Response to "1st batch of Qualification Lots"

Response Clemens Quinones/Cebu/Fairchild 06/07 04:09 PM	Subject:	>Look Ahead Qualification Assembly Results
	Response to:	1st batch of Qualification Lots
	Category:	Wireless SO-8 Pkg Dev't (FLIP-CLIP Technology, Matrix Mold Thru Gate Design)
	Keywords:	Wireless SO-8 Matrix Package Development

To: patrick@sharpmax.com.hk, Mina Alvarez <mina@pdii.com>
 cc: Clemens Quinones/Cebu/Fairchild@Fairchild (bcc: Ma Cristina B Estacio/Cebu/Fairchild)
 Subject: URGENT: SDI to Correct as per drawing

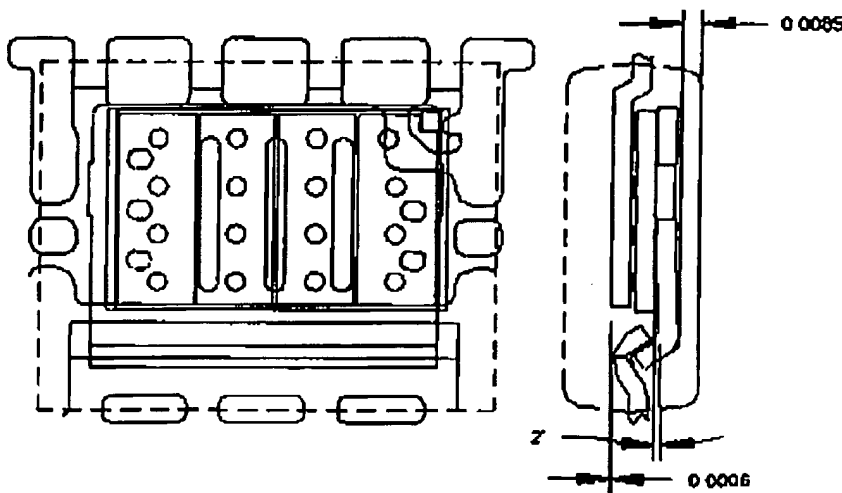
We have made some actual crosssections on the units and the actual parts do not meet as per dimensional requirement. Pls discuss this with your Engg guys so we can correct on the 200K order. Pls confirm ASAP.

Attached is the build diagram of the frame design with the die. These are the dimensional comparison made:

Clip angle 2 degrees 5 - 6 degrees

Level difference 0.6 mil 2.6 - 2.8 mils

bet. v-groove and pad.

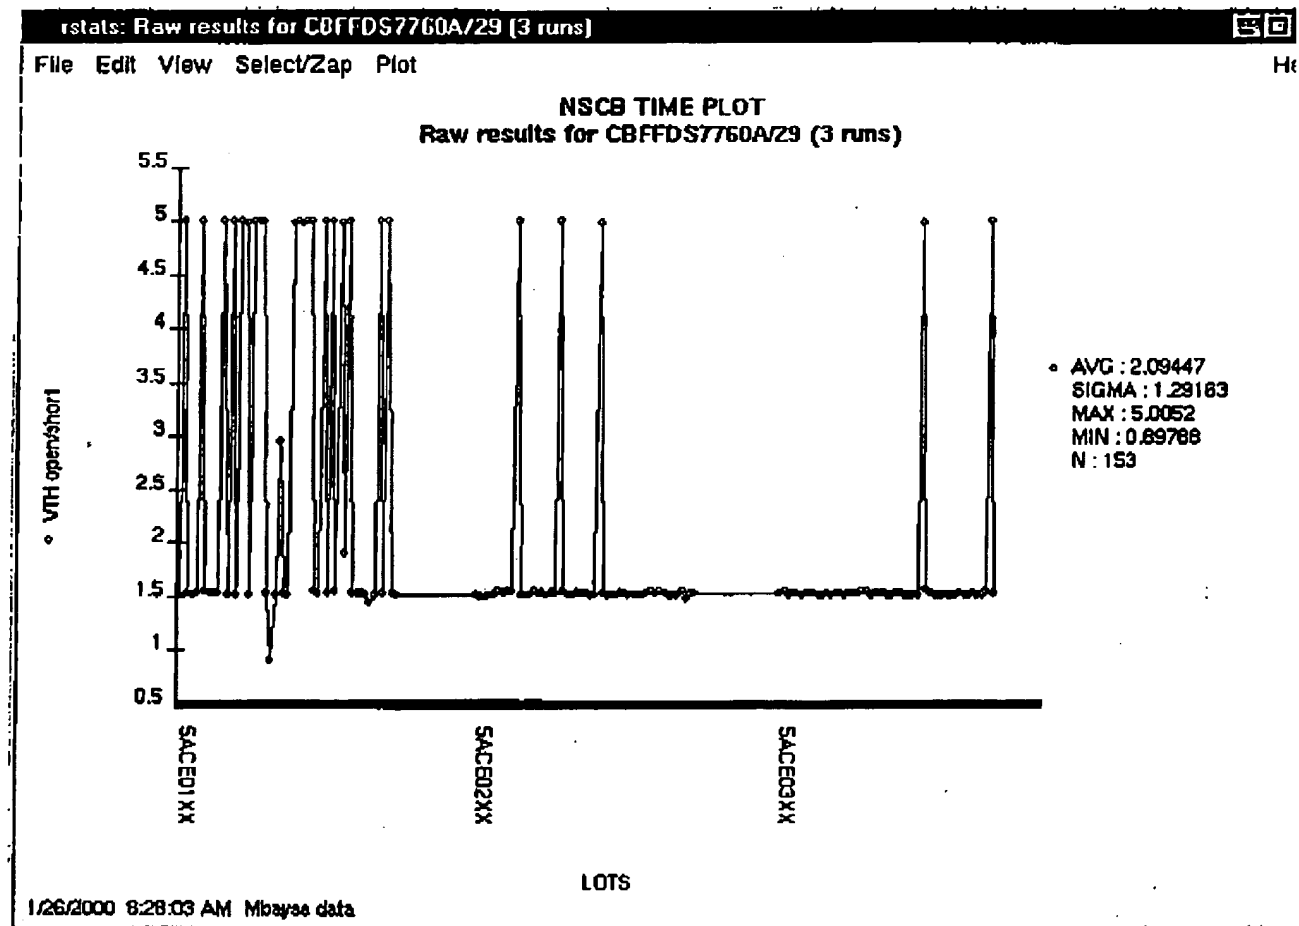
If we meet dimensions as per dwg, clearance from the clip to the mold pkg is 8.5 mils, currently this is very small as per actual cross-sections.

flipclip.jpg topframe.jpg

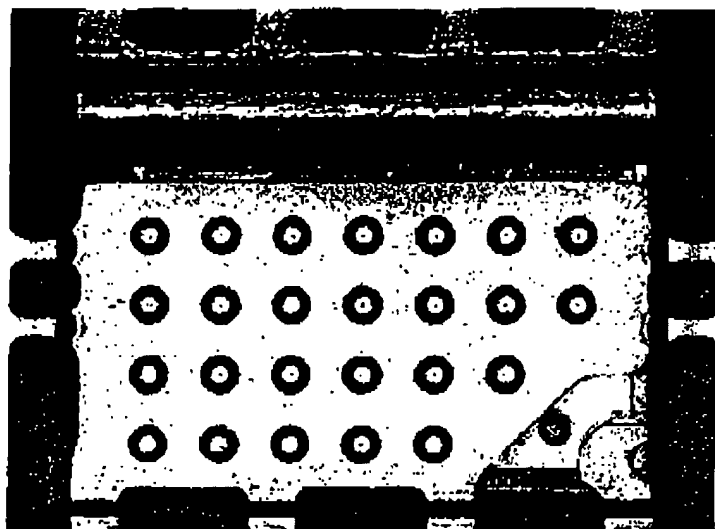
We have inspected the actual units and more or less the attached drawing represents how the units look like (actual measurements can only be available after we can sample some units for crosssection.) The concern is on the amount of paste dispensed on the die backside during clip attach. This was highlighted during the sample builds that we have done when I was there but since we did not have the luxury to further optimize the amount of paste dispensed both on the die back and v-groove, the suggestion based on the informal discussions that we had was to redesign the dispense tool. Pls confirm if the dispense tool with the optimum design will be available upon shipment of the clipbender.

I am also sending a picture of one unit from the actual build.
